DLL state diagram mappings v100

Info (not part of baseline)

Figure 145–13 — Top level PSE state diagram

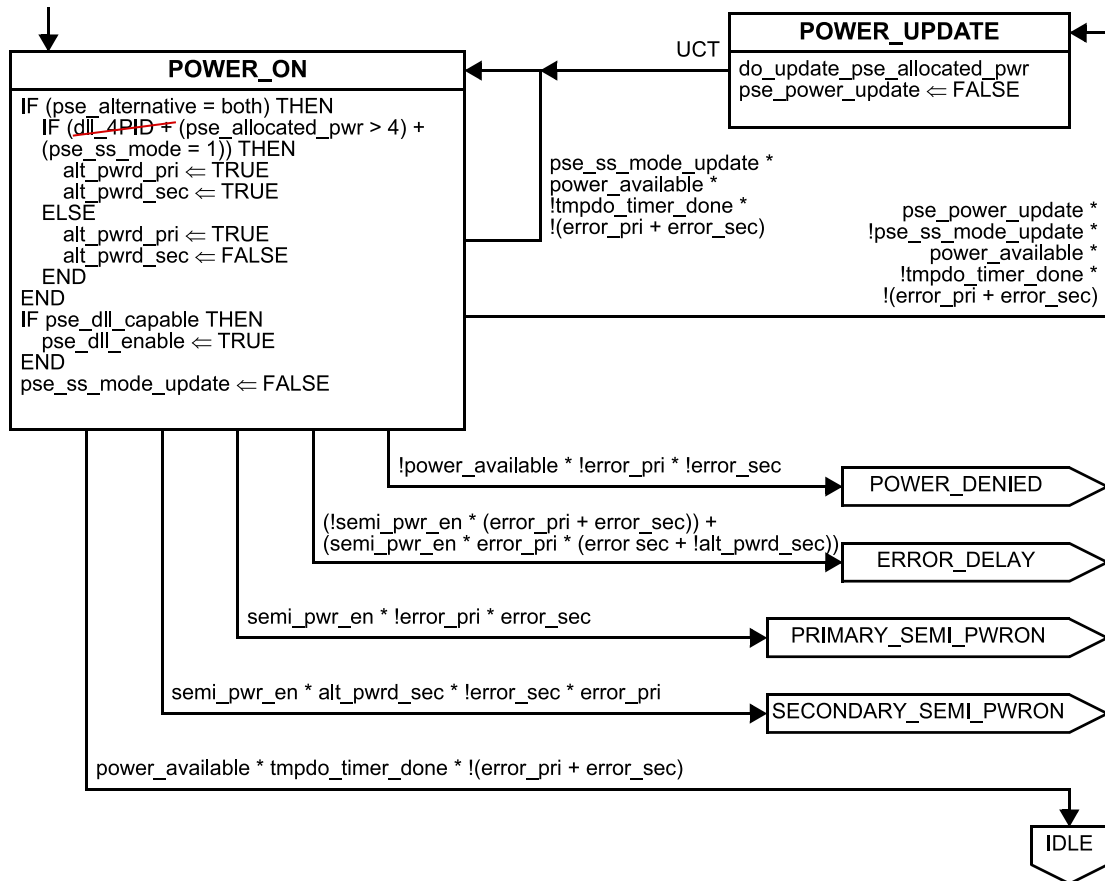
When restructuring the DLL section and splitting up the “attribute to state diagram variable” mapping Tables, several errors were made.

A somewhat related issue is that the variable `dll_4PID`, when set, forces a 4-pair capable PSE to provide 4-pair. The intent of `dll_4PID` was to provide extra information, it should not actually mandate any particular behavior. Note that this variable is removed from the PSE side of things only. On the PD side it remains in use in the state diagram, as Type 3 and Type 4 PDs are required to set this bit.

Change Figure 145–13 (page 142) as follows:

Remove variable `dll_4PID`.
